REQUEST FOR INFORMATION	DATE: January 06, 2017	NO.: RFI-402
--------------------------------	-------------------------------	---------------------

Project Name:	15051-Webster University Interdisciplinary Science Building	Project No.: 15051
---------------	---	--------------------

Subject: OFF. ASP 342 Supply, Transfer Air Duct and Ceiling Conflict.

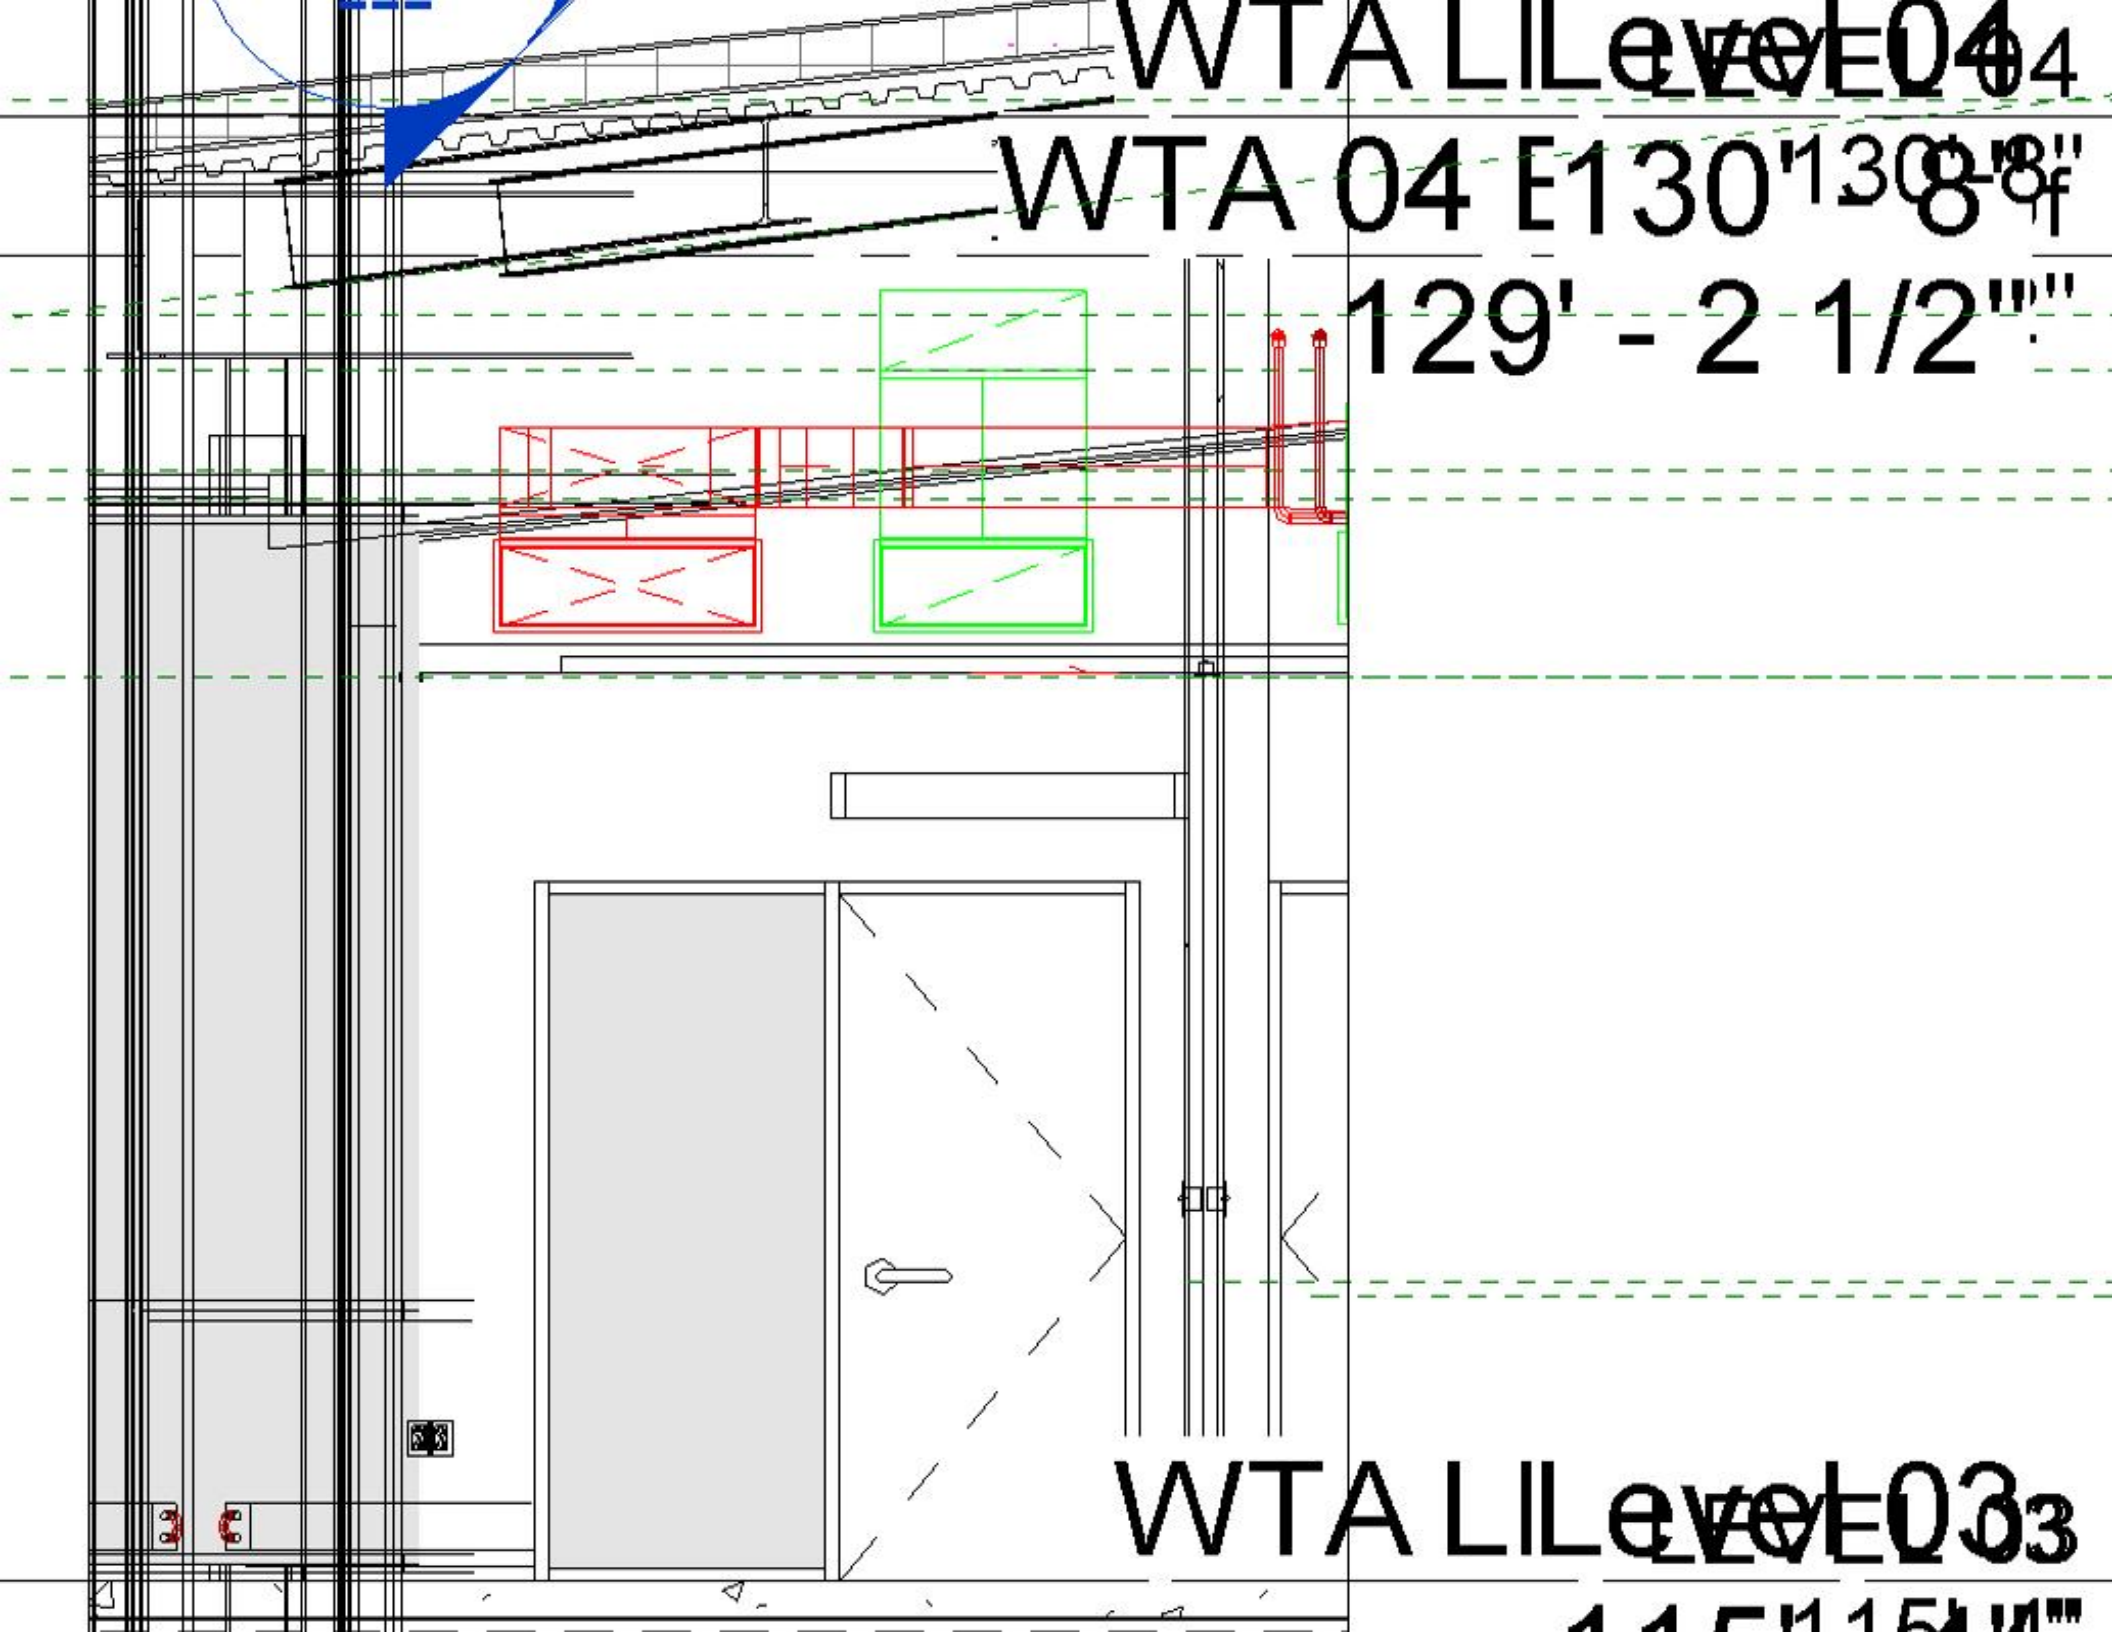
In Office ASP 342, there is a conflict with the sloped ceiling and the supply air and transfer air duct feeding that room. The 32x10 supply does not fit below the ceiling as it stands alone, without the 26x10 transfer duct drawn. Where does the supply air and transfer air duct need to be located to accommodate the limited space created by the sloped ceiling?

Suggestion: If the supply air duct (32x10) can be moved above ceiling and ducted to the ceiling as a standard lay-in diffuser, it should accommodate the transfer air duct (26x10) to run under the sloped ceiling as intended. The transfer air duct can also fit above ceiling and be ducted to the sloped ceiling as well.

Refer to attached screen shot from WTA model showing that the supply and return have enough room to fit as modeled. Contractor to provide Architect and Engineer with additional information regarding reason(s) for less clearance available in Contractor model. Please call Mike Nolte (WTA) and Kelvin Patel (Cannon) to discuss in further detail. If necessary, the supply sidewall grille can shift east, and the return sidewall grille can be shifted west of the supply and return grille mounted to bottom face of soffit with thermostat relocated to adjacent wall to be under the return grille.
